UNITED STATES PATENT AND TRADEMARK OFFICE

APPLICATION NO.	FILING DATE	FIRST NAMED INVENTOR	ATTORNEY DOCKET NO.	CONFIRMATION NO.
10/524,812	02/18/2005	Horst Schulz	ZAHFRI P723US	1653
20210	7590	11/08/2005	EXAMINER	
DAVIS & BUJOLD, P.L.L.C. FOURTH FLOOR 500 N. COMMERCIAL STREET MANCHESTER, NH 03101-1151			MILLS, DANIEL J	
			ART UNIT	PAPER NUMBER
			3679

Office Action Summary

DETAILED ACTION

1,687,019

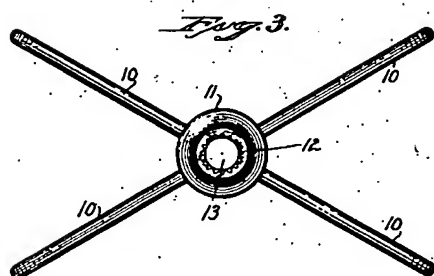
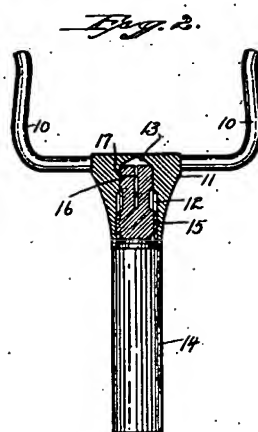
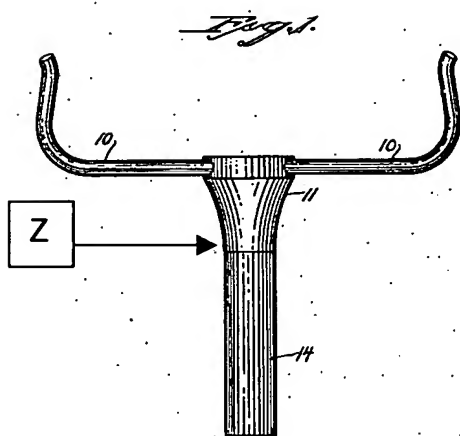
Regarding claim 5, Hallberg discloses a shaft-hub connection between a shaft segment (14), which has one central toothed segment (15), the same as adjacent centering segments (16, C), and a stepped hole (12 and 13) in a hub (11), a shaft and a hub being jointed in an axial direction and, to produce a positive fit, a counter profile (12) is cut in the hub by the toothed segment (15), a front centering segment (16) in a joint direction has a diameter (d1) and the toothed segment (B), the same as a rear centering segment (C) lying in a joint direction, has a diameter (d2) larger than the diameter (d1) of the front centering segment (A), the hole has only two adjacent segments (12 and 13) with different diameters (D1, D2), that the diameter (d1) in the front centering segment (16) with a diameter (D1), the same as the diameter (d2) in the rear centering segment (C) with a diameter (D2), forms a respective joint fit and the diameter (d2) in the central toothed segment (B) with the diameter (D1) forms the positive fit.

Regarding claim 6, Hallberg discloses a shaft-hub connection wherein between the central toothed segment (15) and the front centering segment (16) one other

segment (D) is located which has a diameter (d3) smaller than the diameter (d1) of the front centering segment (16).

Regarding claim 8, Hallberg discloses a shaft-hub connection wherein the centering segment (16) changes over to a shaft collar (at C) which abuts on a front face (at Z) of the hub.

Regarding claim 9, Hallberg discloses a shaft-hub connection between a shaft segment (14) and a hub (11), the shaft segment having one central toothed segment (15) and adjacent centering segments (16 and C), the hub having a stepped hole (12 and 13), the shaft segment and hub being jointed in an axial direction and to produce a positive fit a counter profile is cut in the hub (12) by the central toothed segment (15), a front centering segment (16) in a joint direction has a first diameter (d1), the central toothed segment and the rear centering segment (C) lying in the joint direction have a second diameter (d2), the second diameter (d2) is larger than the first diameter (d1), the stepped hole has a third segment (12 and 13) with a third diameter (D1) and a fourth segment (at Z which accommodates the non-toothed portion C of the shaft) with a fourth diameter (D2), the first diameter (d1) is approximately equal to the third diameter (D1), the second diameter (d2) is approximately equal with to fourth diameter (D2), the front centering segment (16) of the shaft segment and the third segment of the stepped hole forming a joint fit, the rear centering segment (C) of the shaft segment (2) and the fourth segment of the stepped hole forming another joint fit, the rear centering segment (C) of the shaft segment and the third segment of the stepped hole forming a positive fit.

Regarding claim 10, Hallberg discloses a shaft-hub connection wherein one additional segment (D) is located between the front centering segment (16) and central toothed segment (15) and has a third diameter (d3) smaller than the first diameter (d1).

Regarding claim 12, Hallberg discloses a shaft-hub connection wherein the rear centering segment (C) changes into a shaft collar (at C) which abuts on a front face (at Z) of the hub (3).

Regarding claim 7, Hallberg discloses a shaft-hub connection wherein the toothed segment (B) has one toothing (5) with a root diameter (dF) and that the diameter (d3) is \leq the root diameter (dF). Hallberg fails to disclose that the teeth are formed by a knurling process, However it would have been a simple matter of engineering design choice at the time of applicant's invention, to use a knurling process to form teeth for the purpose of reducing cost. Accordingly, it would have been ~~obvious~~ ^{obvious to one of ordinary skill in the art} at the time of applicant's invention to modify the arrangement of Hallberg to include knurled teeth.

Regarding claim 11, Hallberg discloses a shaft-hub connection wherein the central toothed segment (15) has one toothing with a root diameter (d_F), the third diameter (d_3) is less than or approximately equal to the root diameter (d_F). Hallberg fails to disclose that the teeth are formed by a knurling process, However it would have been a simple matter of engineering design choice at the time of applicant's invention, to use a knurling process to form teeth for the purpose of reducing cost. Accordingly, it would have been obvious at the time of applicant's invention to modify the arrangement of Hallberg to include knurled teeth.
